**THE FIRST MEETING OF THE APANPIRG AERODROMES
OPERATIONS AND PLANNING – WORKING GROUP (AOP/WG/1)**

AMENDMENT 5 TO ANNEX 14, VOLUME II — HELIPORTS

This paper provides update on the new Amendment 5 to Annex 14, Volume II – *Heliports*.

Figure 3-1. FATO and associated safety area

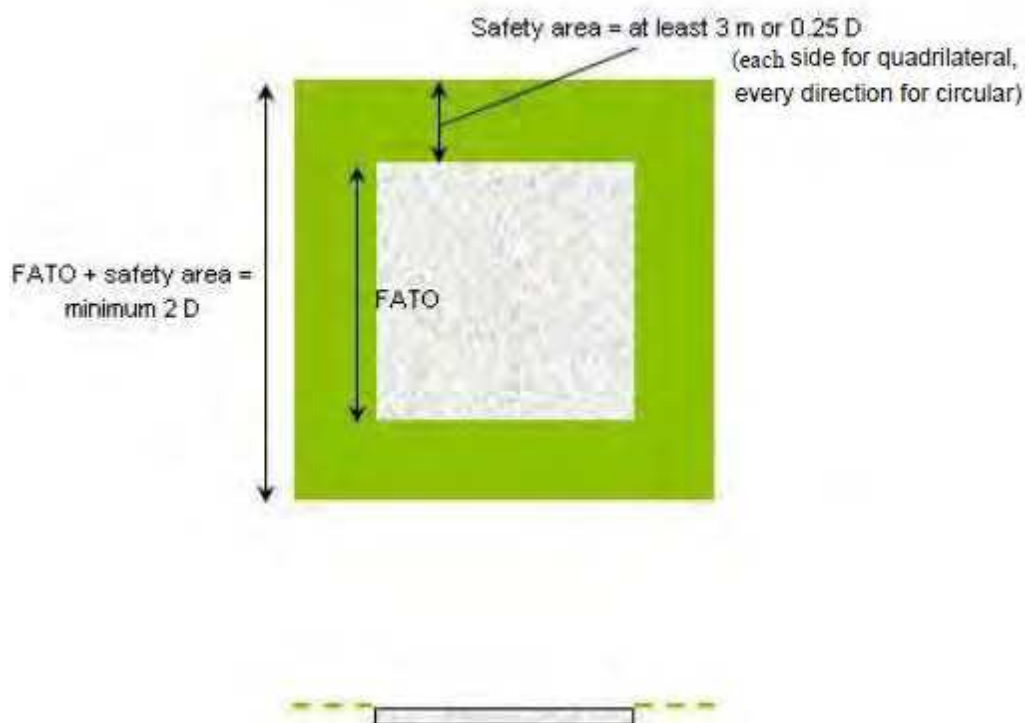
3.1.24 No fixed object shall be permitted above the plane of the FATO on a safety area, except for frangible objects, which, because of their function, must be located on the area. No mobile object shall be permitted on a safety area during helicopter operations.

- a) if located at a distance of less than 0.75 D from the centre of the FATO, penetrate a plane at a height of 5 cm above the plane of the FATO; and
- b) if located at a distance of 0.75 D or more from the centre of the FATO, penetrate a plane originating at a height of 25 cm above the plane of the FATO and sloping upwards and outwards at a gradient of 5 per cent.

Editorial Note.— *Editorial Note.*— Replace Figure 3-1 with new Figure 3-1 as follows:
(existing Figure 3-1 is relocated to Appendix 2 Figure A3-1)

Figure 3-2. Helicopter ground taxi-route/taxiway

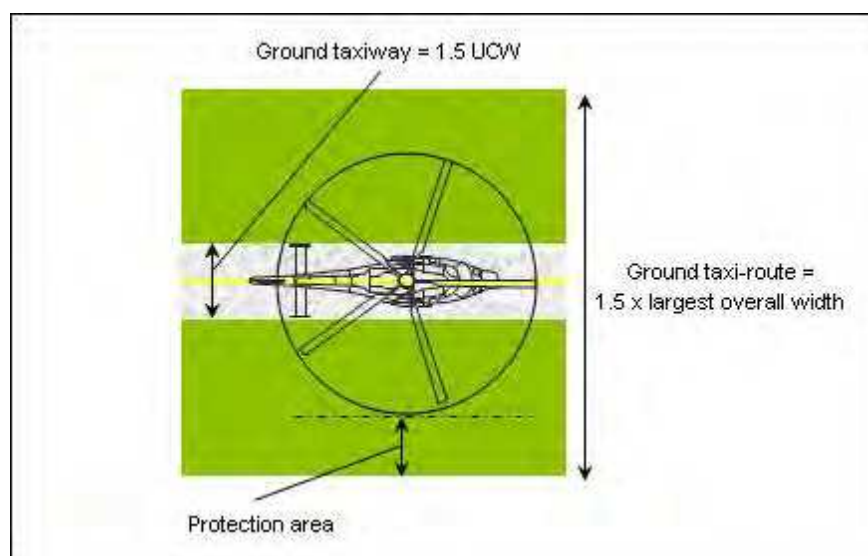
3.1.3029 The width of a helicopter ground taxiway shall not be less than 1.5 times the largest width of the undercarriage (UCW) of the helicopters the helicopter ground taxiway is intended to serve (see Figure 3-2).

Editorial Note.— Replace Figure 3-2 with new Figure 3-2 as follows:

Figure 3-3. Helicopter air taxi-route/taxiway

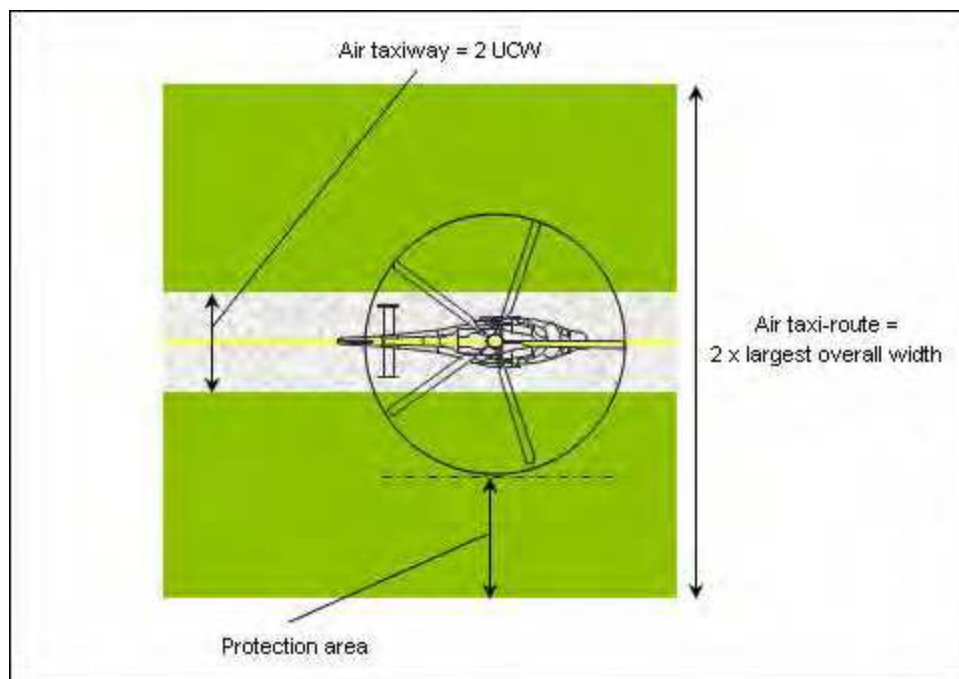
3.1.3839 The width of a helicopter air taxiway shall be at least two times the largest width of the undercarriage (UCW) of the helicopters that the helicopter air taxiway is intended to serve (see Figure 3-3).

Editorial Note.— Replace Figure 3-3 with new Figure 3-3 as follows:

Figure 3-4. Helicopter stand and associated protection area

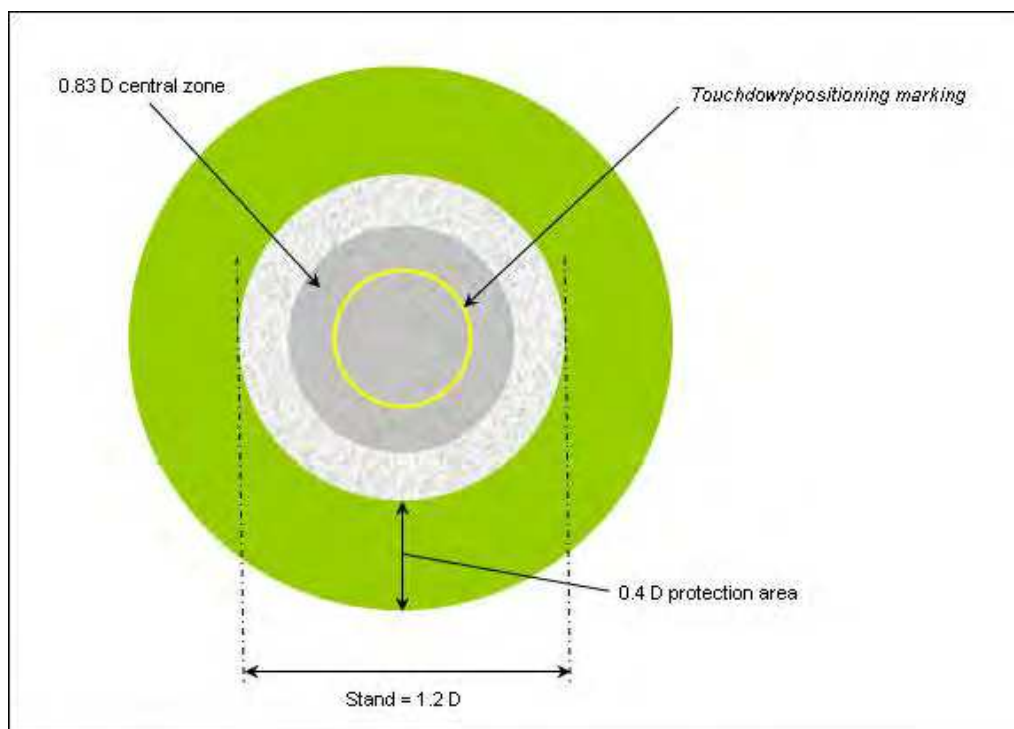
3.1.5052 A helicopter stand intended to be used by helicopters turning in a hover shall be of sufficient size to contain a circle of diameter of at least 1.2 D of the largest helicopter the stand is intended to serve (see Figure 3-4).

3.1.5153 ~~When~~ Where a helicopter stand is intended to be used for taxi-through and where the helicopter using the stand is not required to turn, the minimum width of the stand and associated protection area shall be that of the taxi-route (see Figure 3-4).

3.1.5254 ~~When~~ Where a helicopter stand is intended to be used for turning, the minimum dimension of the stand and protection area shall be not less than 2 D (see Figure 3-5).

Editorial Note.— Replace Figure 3-5 with new Figure 3-4 as follows:

Figure 3-5. Helicopter stands designed for hover turns with air taxi-routes/taxiways — simultaneous operations

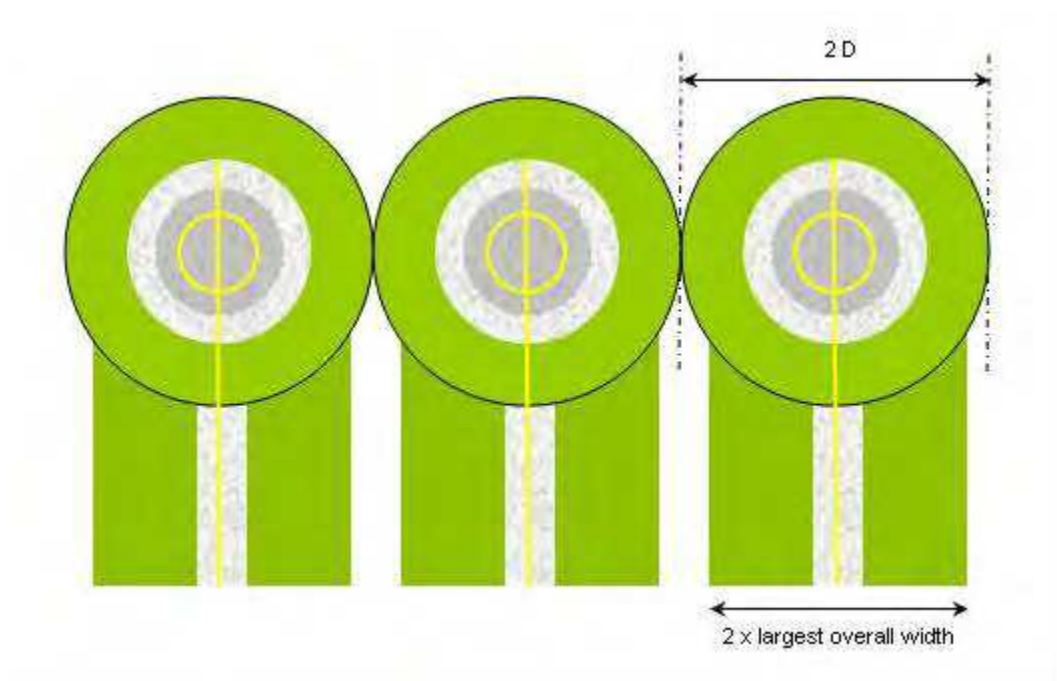
3.1.5456 For simultaneous operations, the protection areas of helicopter stands and their associated taxi-routes shall not overlap (see Figure 3-65).

Editorial Note.— Replace Figure 3-6 with new Figure 3-5 as follows:

Figure 3-6. Helicopter stands designed for hover turns with air taxi-routes/taxiways — non-simultaneous operations

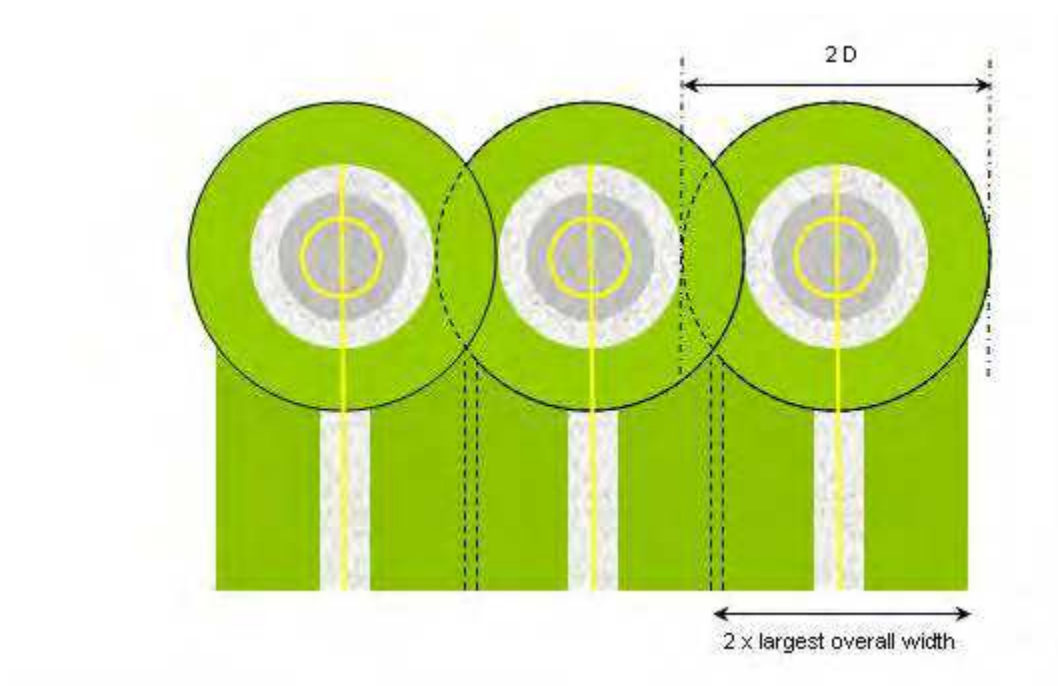
Note.— Where non-simultaneous operations are envisaged, the protection areas of helicopter stands and their associated taxi-routes may overlap (see Figure 3-76).

Editorial Note.— Replace Figure 3-7 with new Figure 3-6 as follows:

Figure 4-8. Helideck obstacle limitation sectors and surfaces for a FATO and coincidental TLOF of 1D and larger.

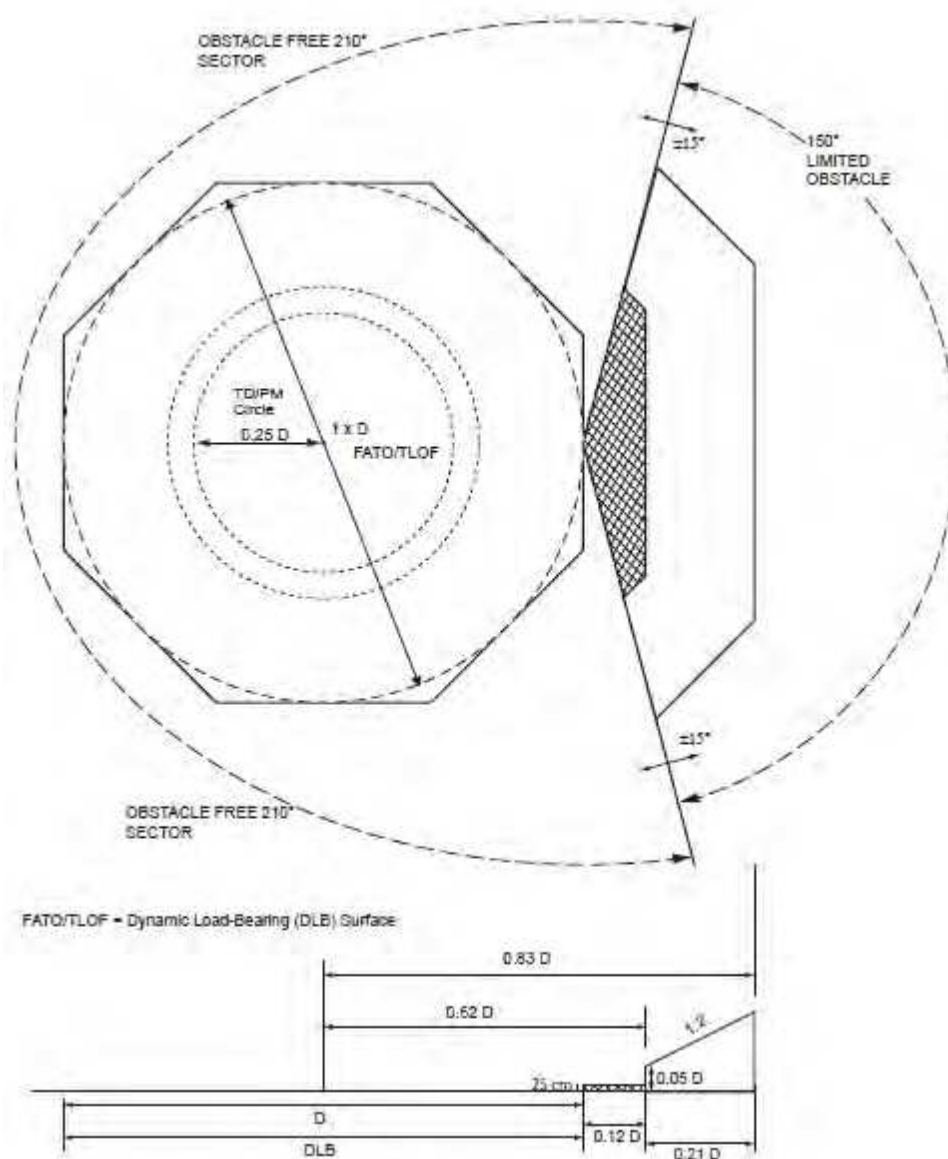
4.2.16 For a TLOF of 1D and larger, within the 150-degree limited obstacle surface/sector out to a distance of 0.62D, measured from the centre of the FATO, 0.12D measured from the point of origin of the limited obstacle sector, objects shall not exceed a height of 0.05D 25 cm above the FATO-TLOF. Beyond that arc, out to an over-all distance of 0.83D a further 0.21D measured from the end of the first sector, the limited obstacle surface rises at a rate of one unit vertically for each two units horizontally originating at a height 0.05D above the level of the TLOF (see Figure 4-38).

Editorial Note. Delete existing Figure 4-3. Add new Figure 4-8. Helideck obstacle limitation sectors and surfaces for a 1D FATO/TLOF.

Figure 4-9. Helideck obstacle limitation sectors and surfaces for a TLOF of 0.83D and larger.

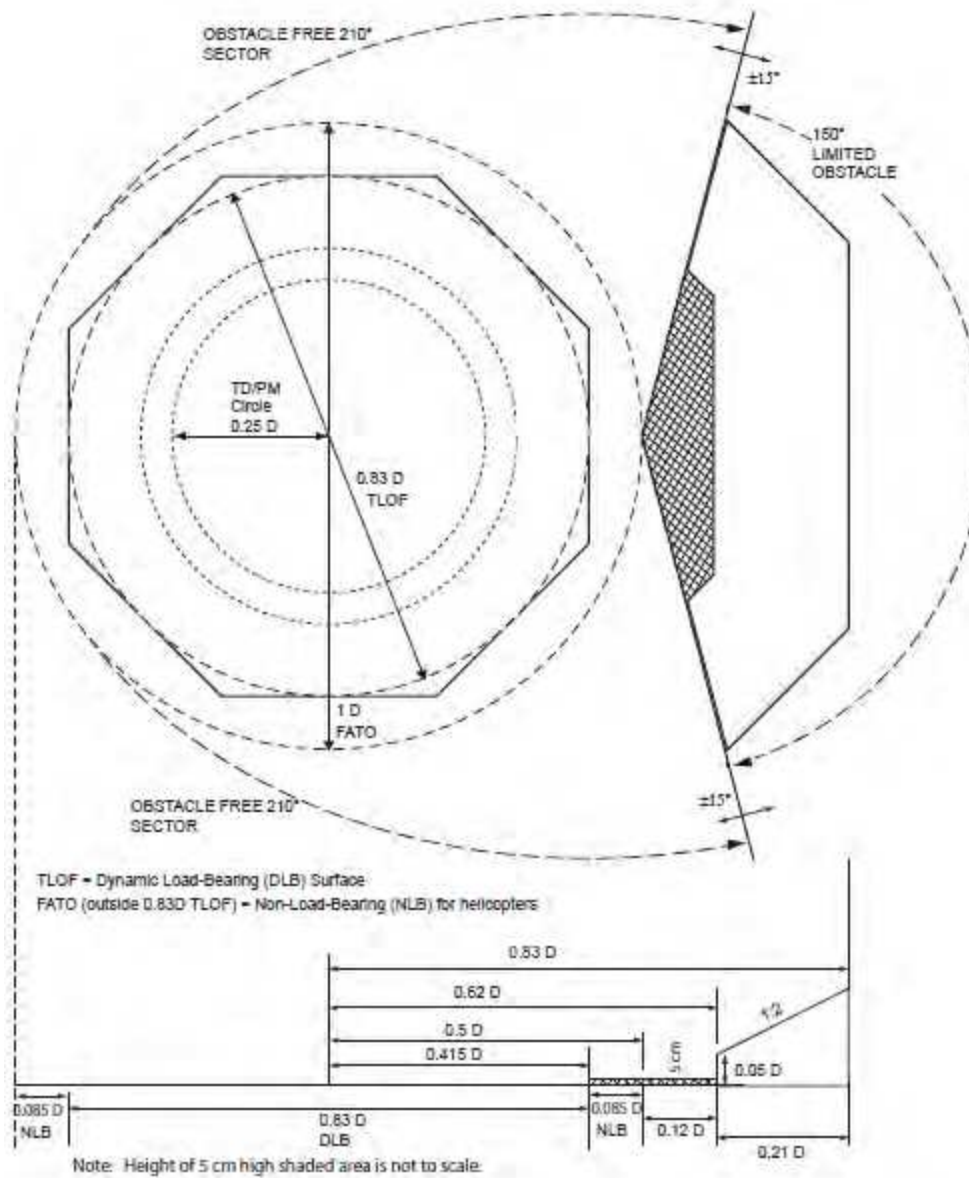
Beyond that arc, out to an overall distance of 0.83D from the centre of the TLOF, the limited obstacle surface rises at a rate of one unit vertically for each two units horizontally originating at a height 0.05D above the level of the TLOF (see Figure 4-9).

Figure 5-1. Combined heliport identification, aiming point and FATO perimeter markings

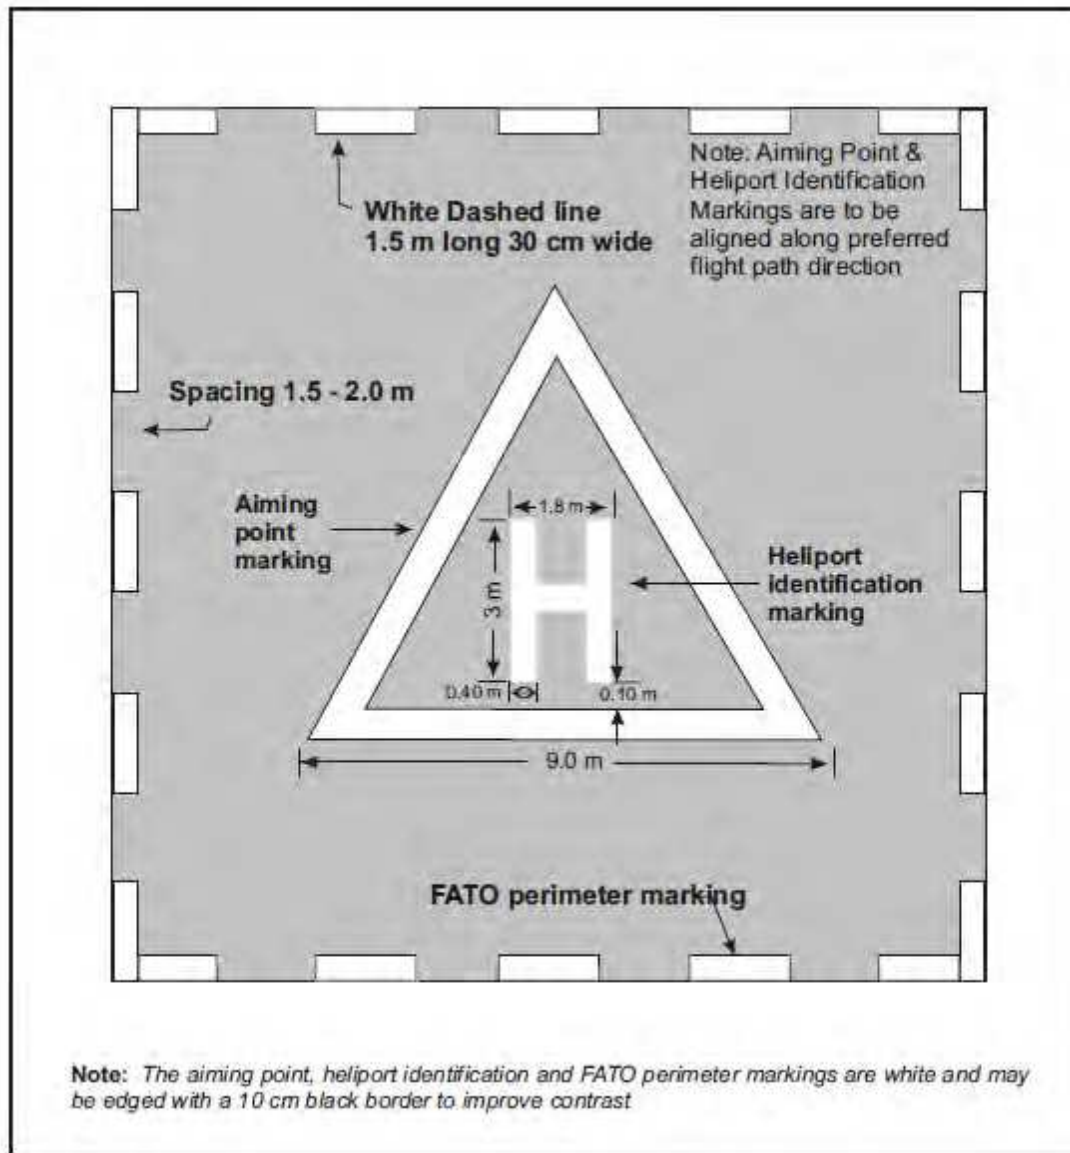
Note 2.- On a FATO, which does not contain a TLOF and which is marked with an aiming point marking (see 5.2.8), except for a heliport at a hospital, the heliport identification marking is established in the centre of the aiming point marking as shown in Figure 5-1.

Editorial Note.— Replace figure 5-1 with new Figure 5-1 as follows:

Figure 5-2. Hospital heliport identification and heliport identification marking

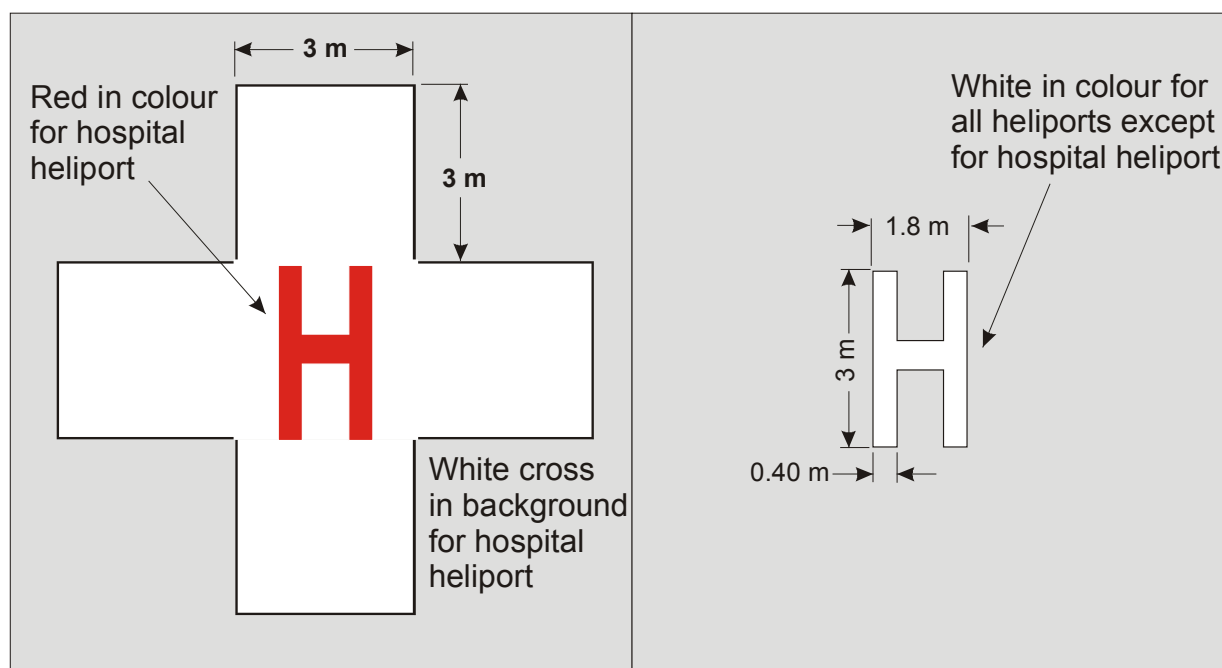
5.2.2.46 A heliport identification marking for a heliport at a hospital shall consist of a letter H, red in colour, on a white cross made of squares adjacent to each of the sides of a square containing the H as shown in Figure 5-12.

Editorial Note.— Replace Figure 5-2 with new Figure 5-2 as follows:

Figure 5-5 Runway-type FATO edge marker

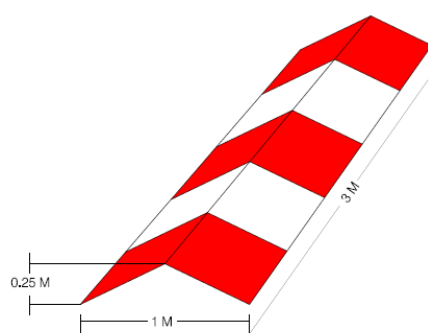
5.2.6.6 A FATO perimeter marker shall have dimensional characteristics as shown in Figure 5-5.

Editorial Note.— New Figure 5-5:

Figure 5-8 Helicopter stand markings

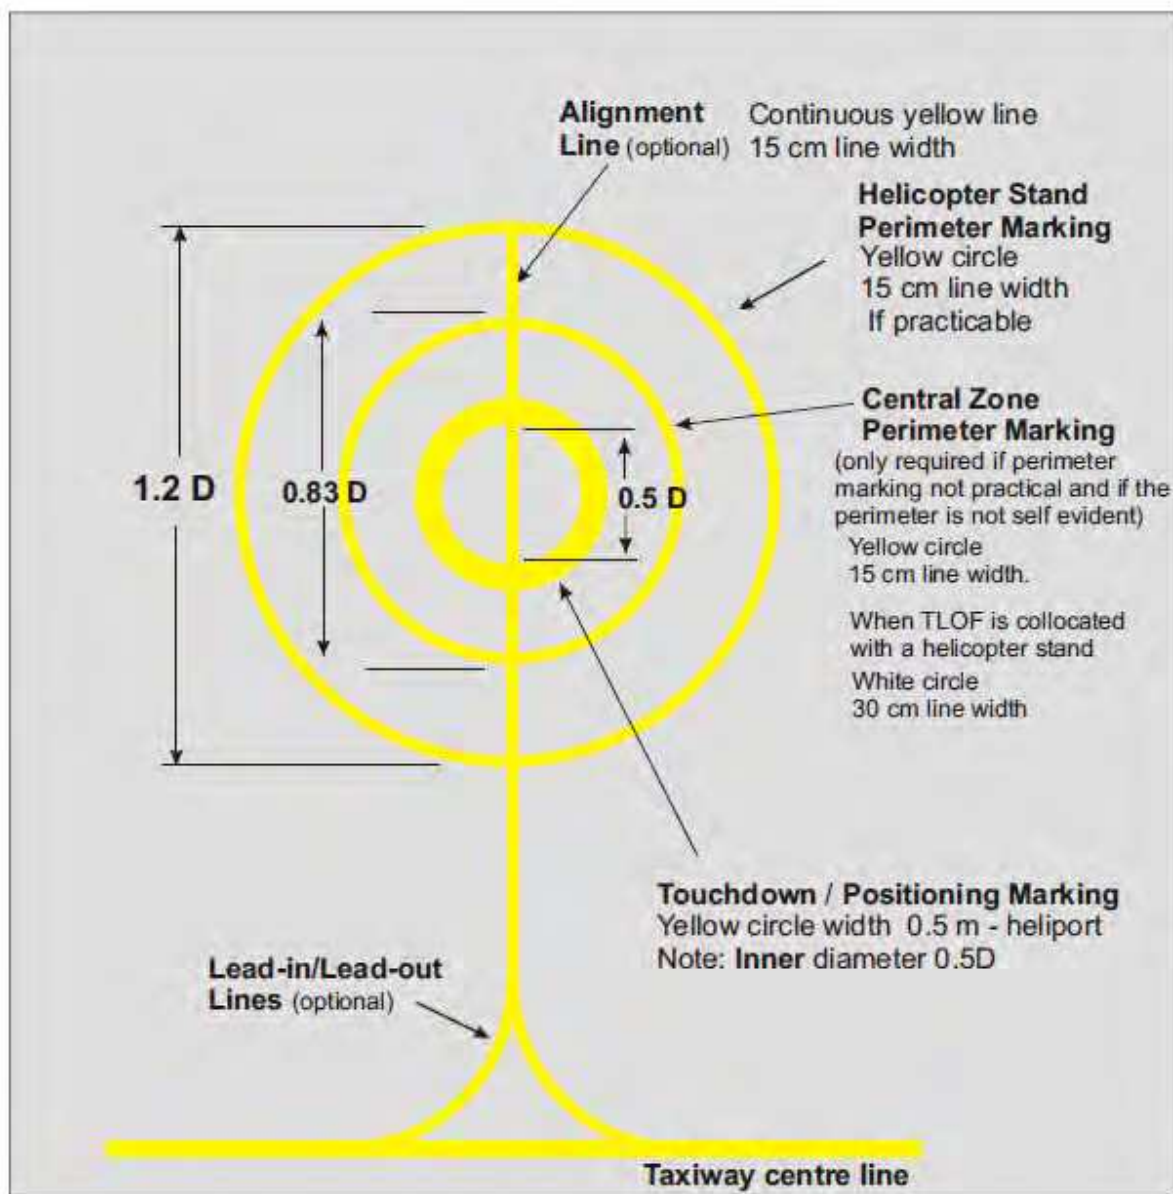
5.2.17.6 Alignment lines and lead-in/lead-out lines shall be located as shown in Figure 5-8.

Editorial Note.— New Figure 5-8:
